ADDENDUM NO. 1

**AASF & Cold Storage Hangar LED Lighting, POV and MVC Expansion
Whiteman Air Force Base
Knob Noster, Missouri
PROJECT NO.: T2045-01**

Bidders are hereby informed that the construction Plans and/or Specifications are modified as follows:

SHEET E-003 CHANGES

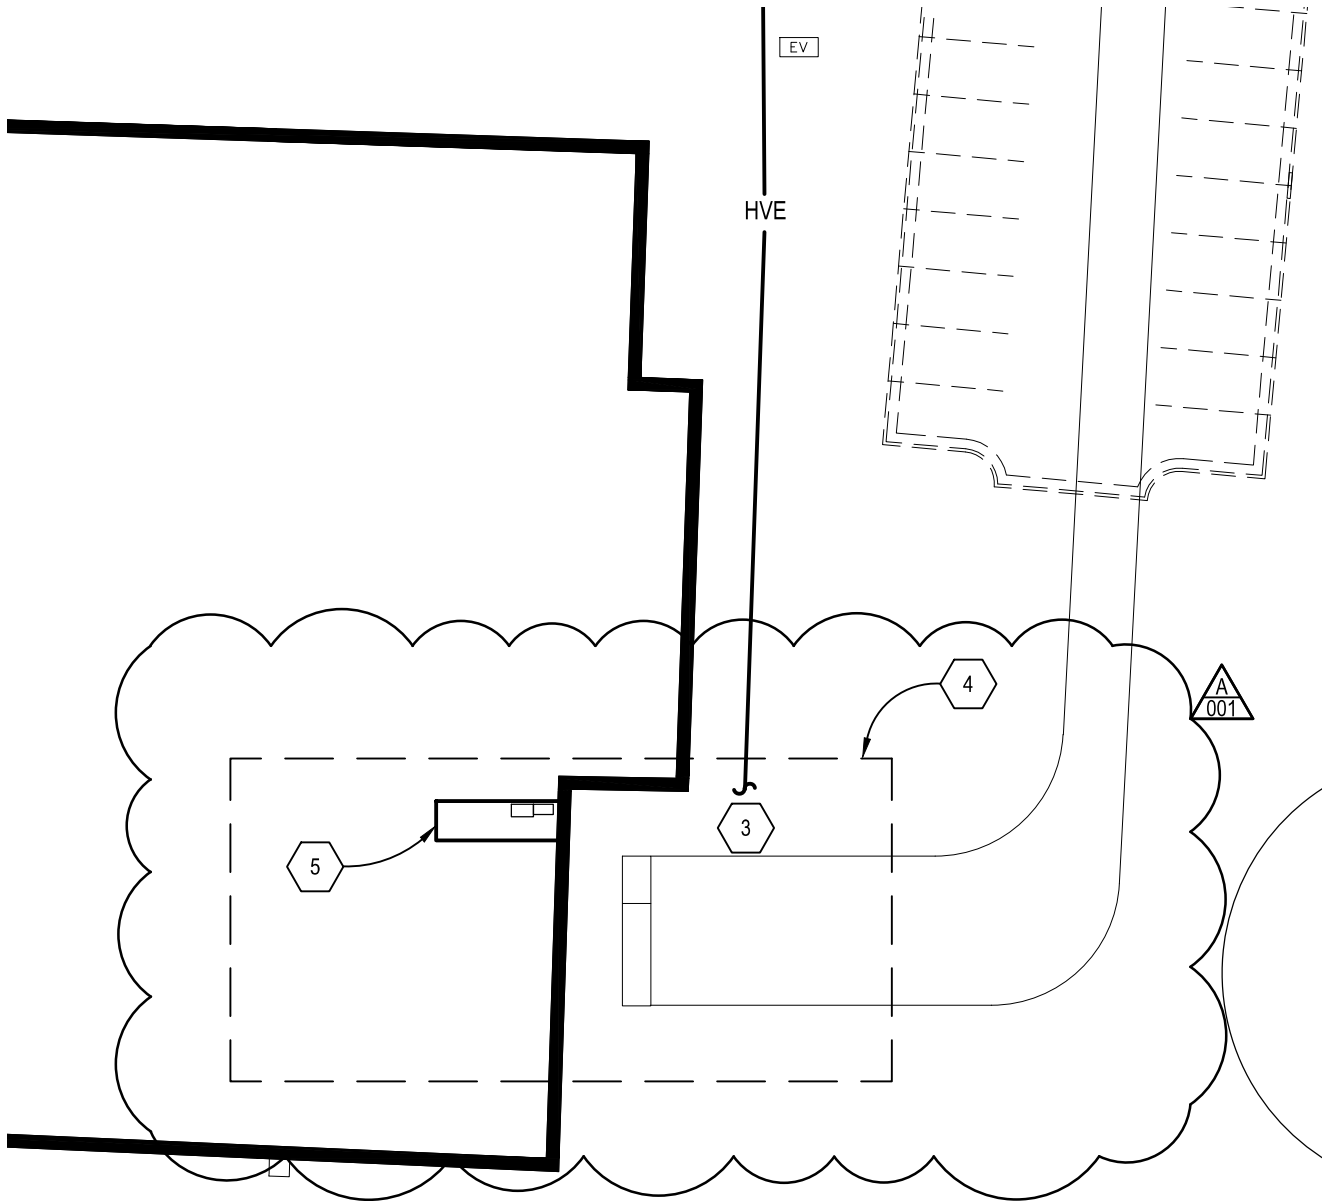
2. Sheet E-003

- a. Revise: The location of the electrical equipment on the southeast side of the existing building has been adjusted.

E-004

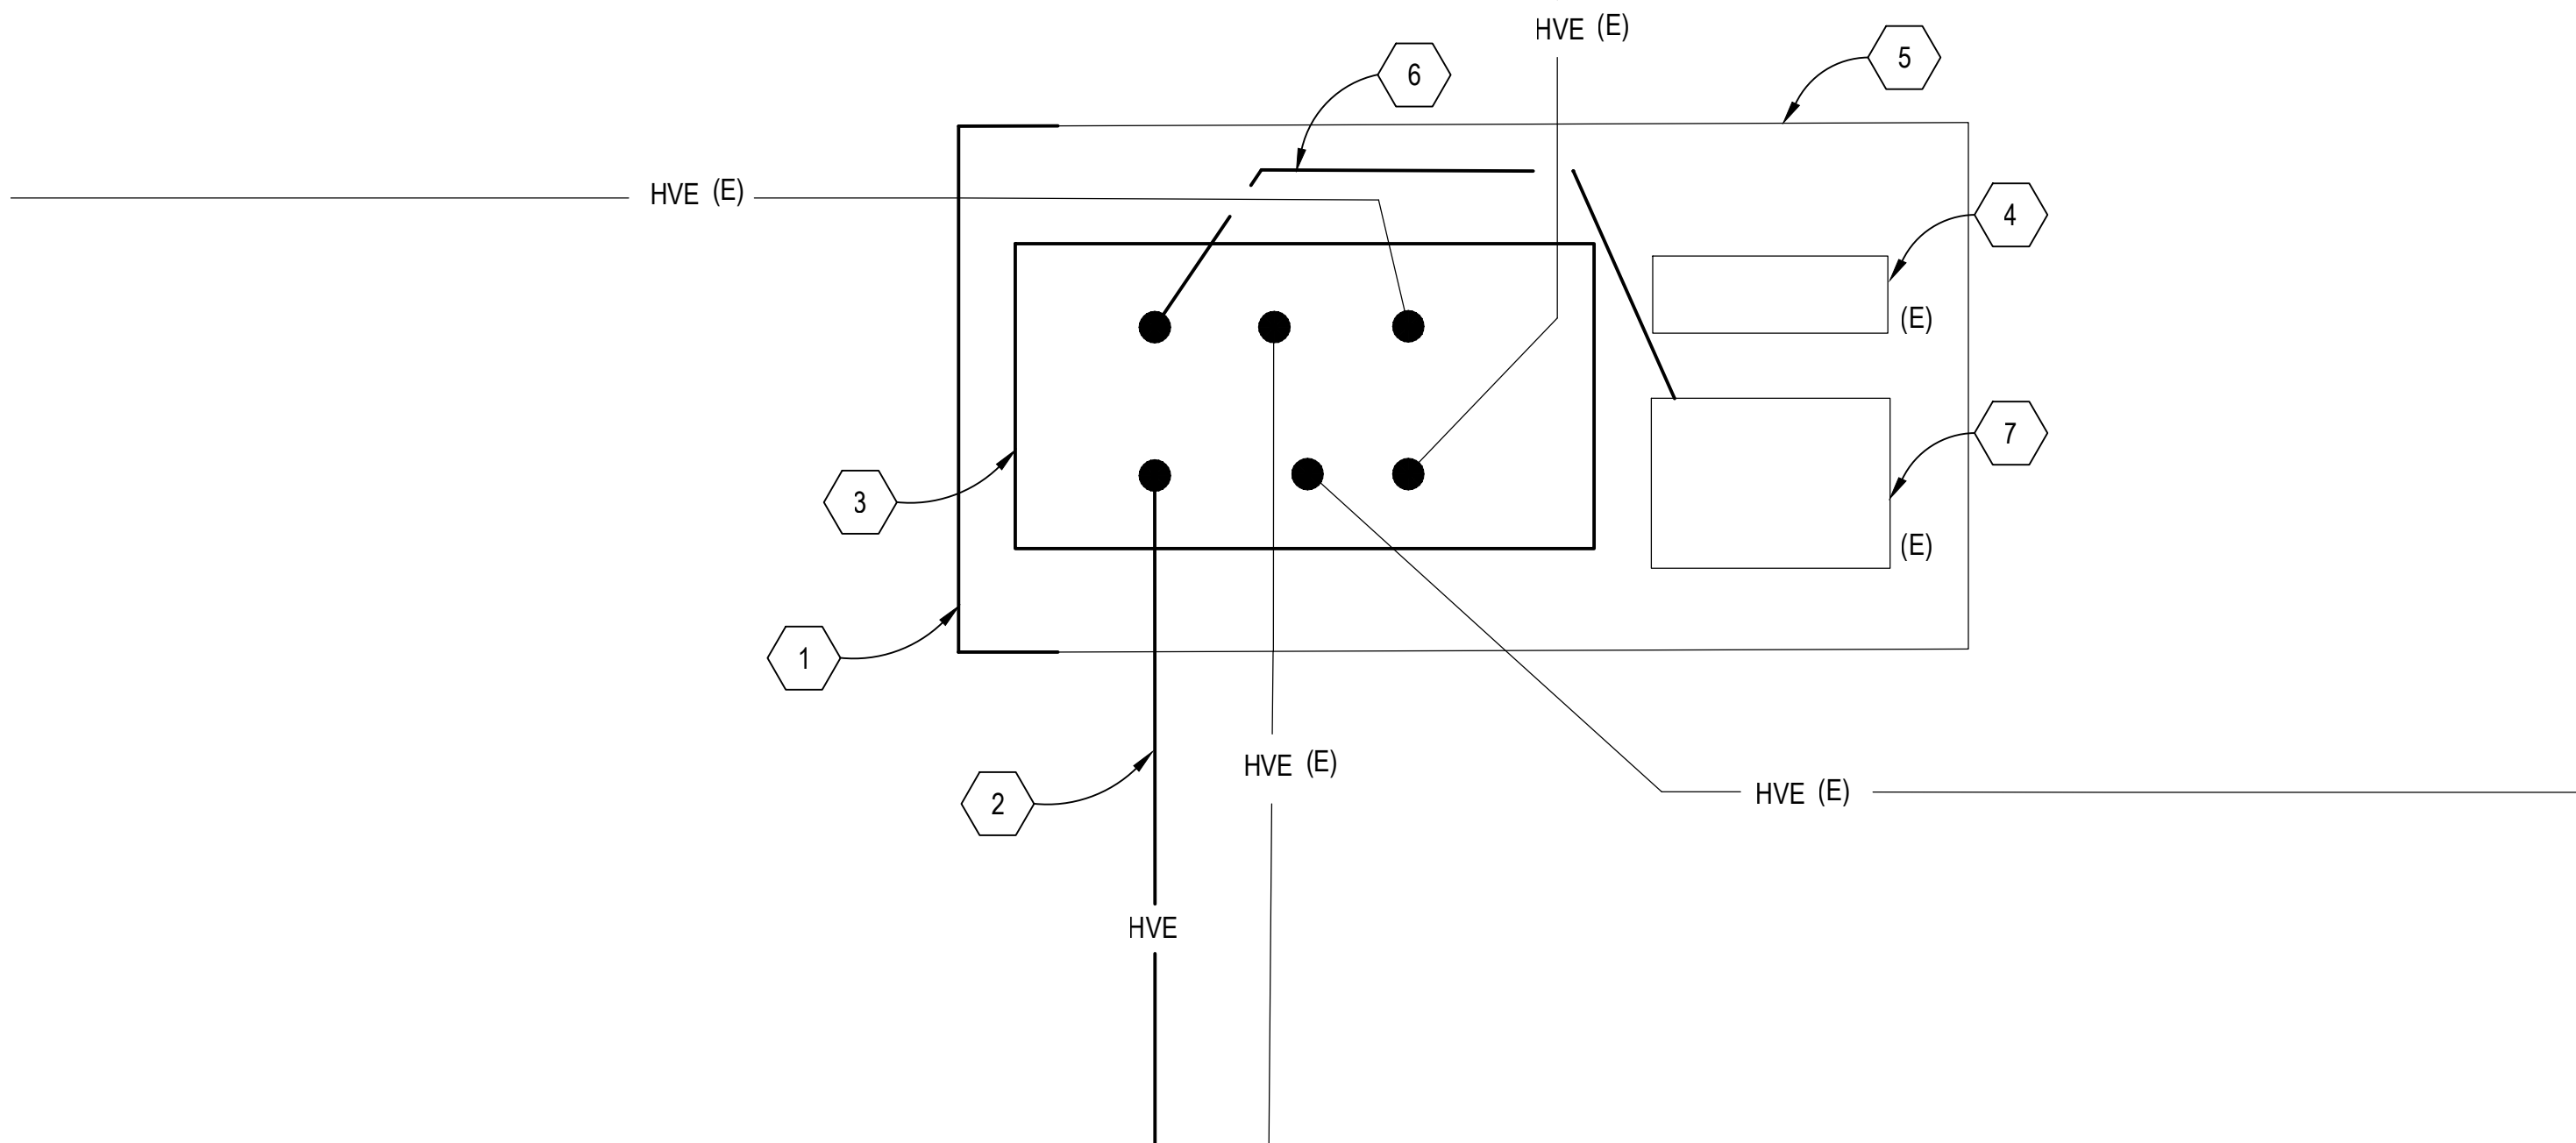
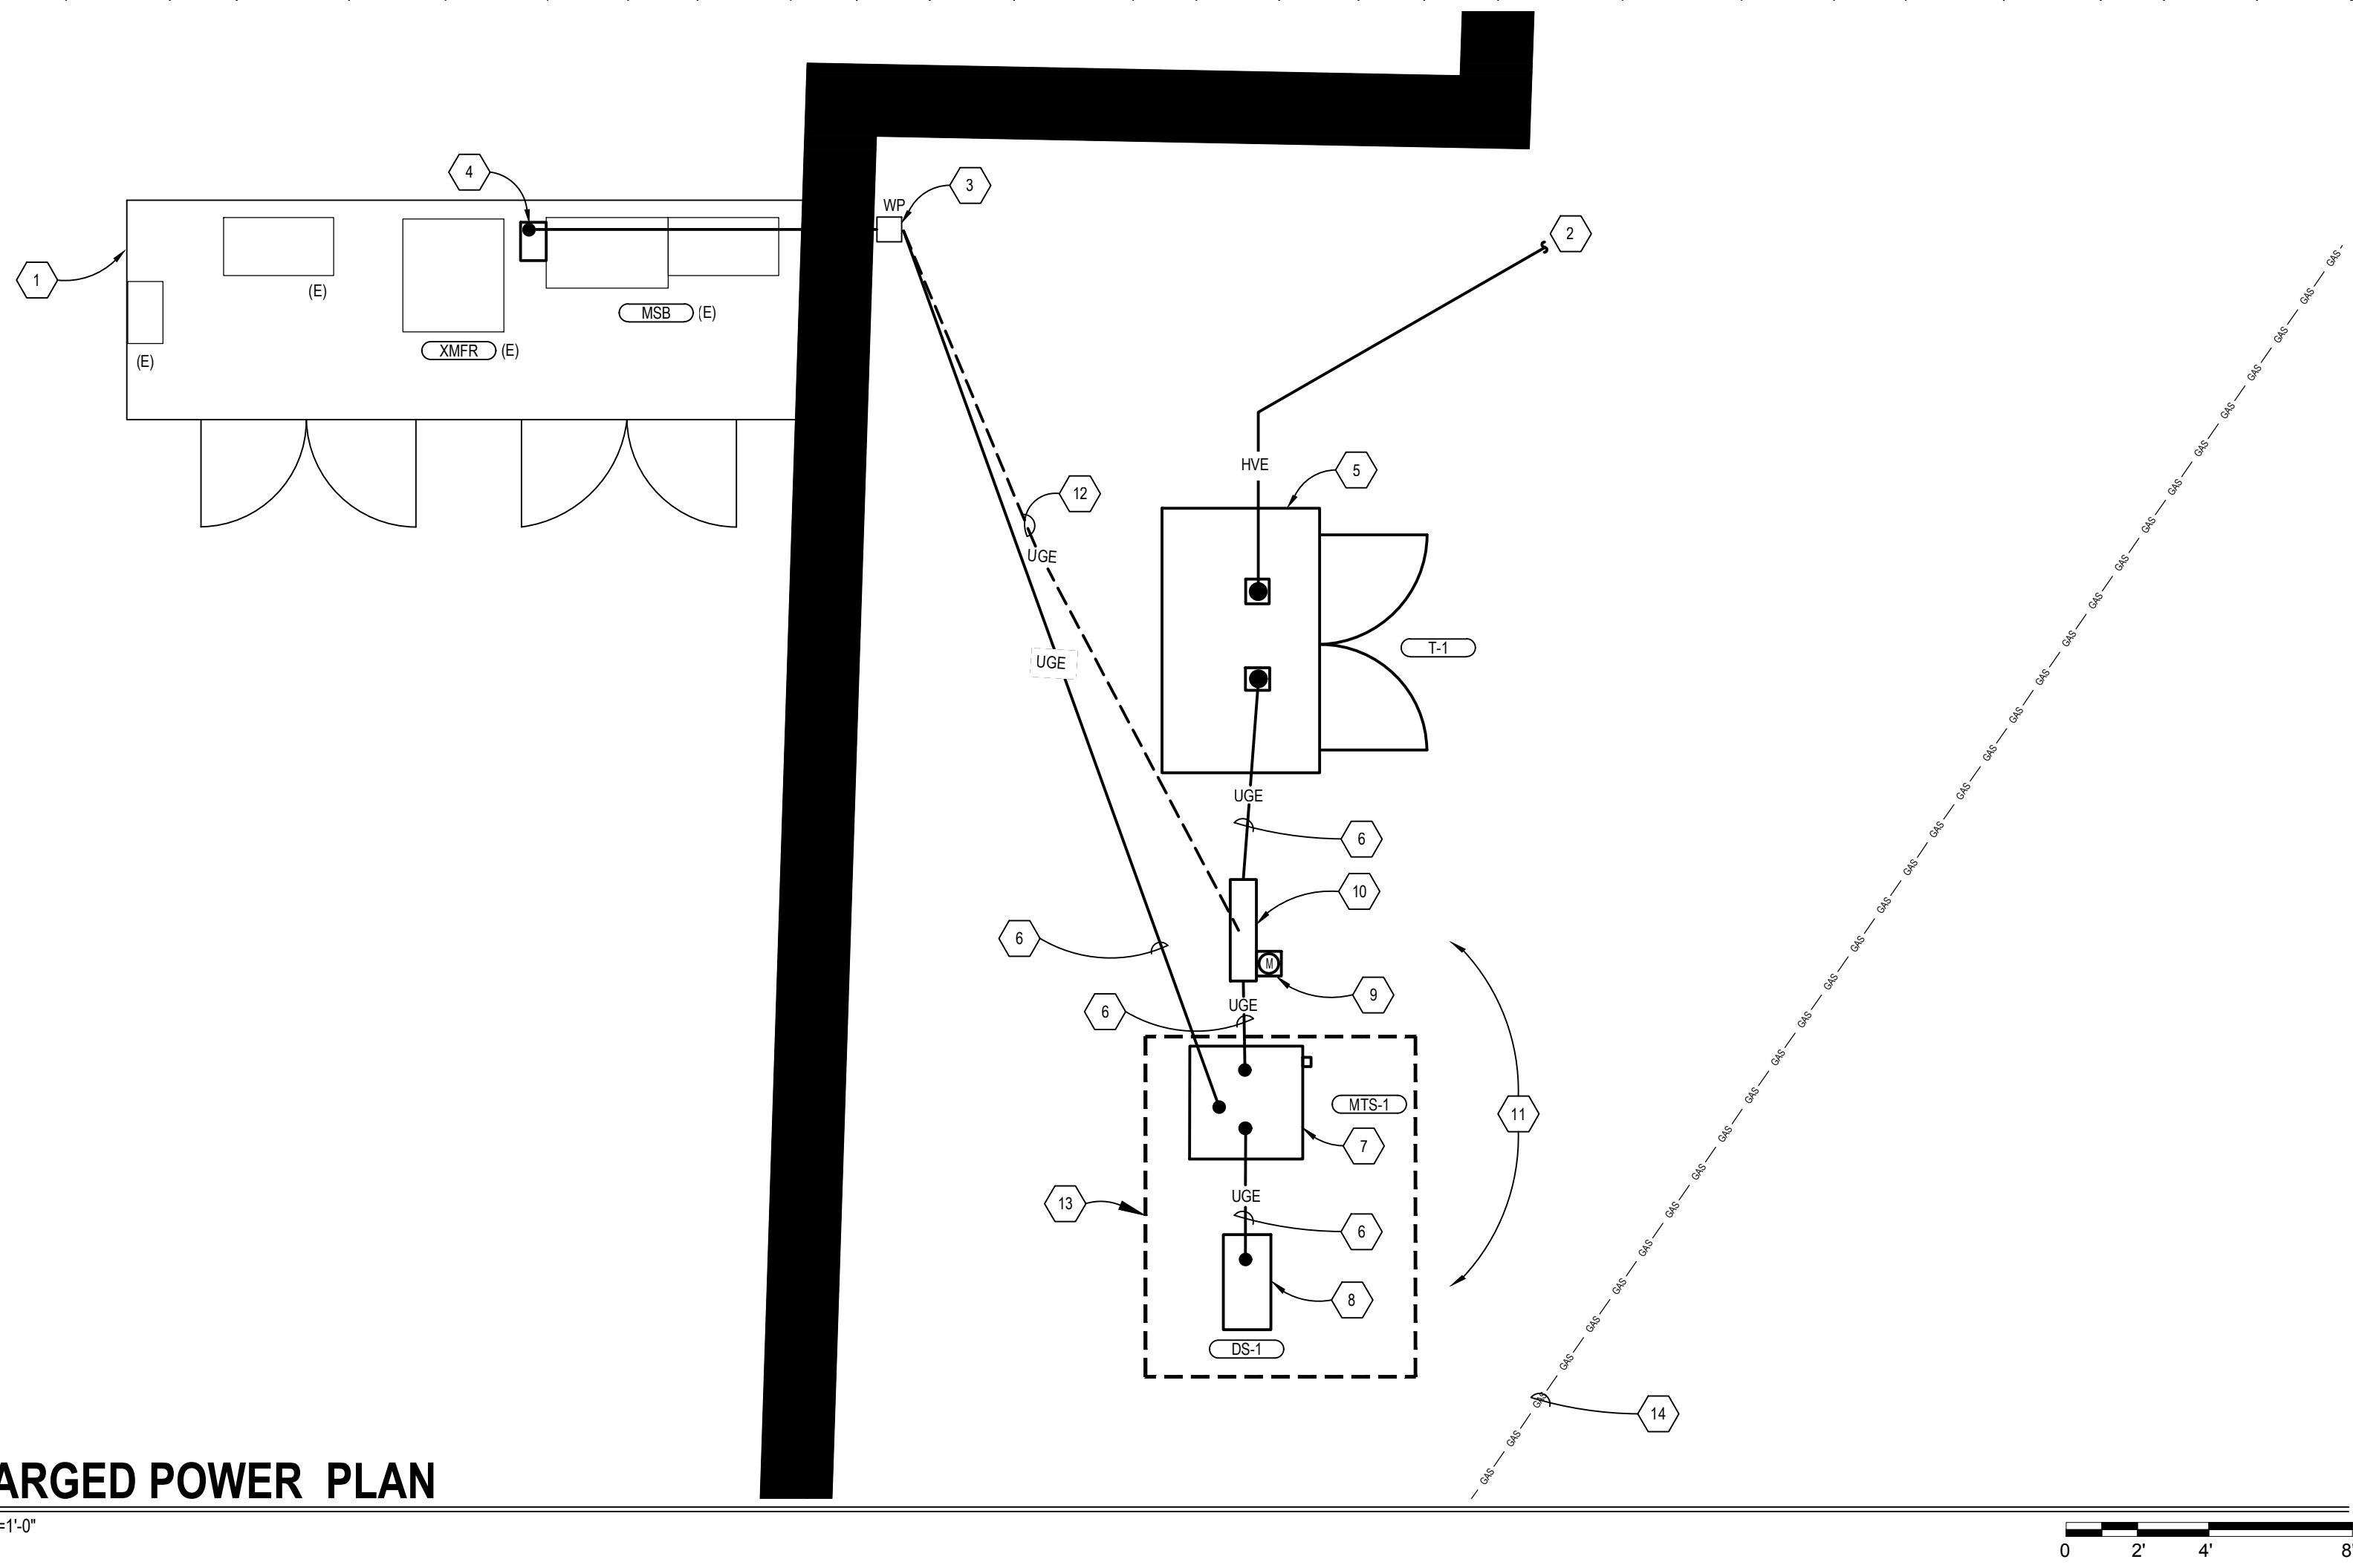
3. Sheet E-004

- a. Revise: Refer to the Enlarged Power Plan. The location of the electrical equipment on the southeast side of the existing building has been adjusted. Added key note 14 to clarify clearances with gas utility line.

10	NEW 480V, 3PH, 800A, NEMA 4X, LOCKABLE, MILBANK (OR ENGINEER APPROVED EQUAL) CURRENT TRANSFORMER (CT) CABINET TO BE MOUNTED ON STAINLESS STEEL UNISTRUT RACK THAT IS SECURED TO CONCRETE PAD. CONTRACTOR TO ENSURE CT CABINET IS COMPATIBLE WITH PROVIDED CURRENT TRANSFORMERS AND METER. PROVIDE ALL NECESSARY EQUIPMENT, WIRE, CONDUIT, AND CONNECTIONS TO ENSURE A COMPLETE METERING INSTALLATION. COORDINATE EXACT INSTALLATION REQUIREMENTS WITH OWNER.
11	REFERENCE LANDSCAPE SITE PLANS FOR CONCRETE PAD INFORMATION IN THIS AREA.
12	UNDER BAS BID CONDITION ONLY, SERVICE ENTRANCE FEEDER SHALL BE ROUTED DIRECTLY FROM THE NEW CT CABINET TO THE EXISTING MAIN SWITCHBOARD, 'MSB'.
13	ALL WORK ASSOCIATED WITH THE INSTALLATION OF 'MTS-1' AND 'DS-1', INCLUDING ASSOCIATED CONCRETE PAD, IS TO BE PERFORMED ONLY IF ADD ALTERNATE #3 IS ACCEPTED.
14	VERIFY LOCATION OF EXISTING GAS UTILITY LINE PRIOR TO PERFORMING ANY WORK IN AREA. ALL ELECTRICAL EQUIPMENT TO MAINTAIN A MINIMUM CLEARANCE OF 6' FROM GAS UTILITY LINE.
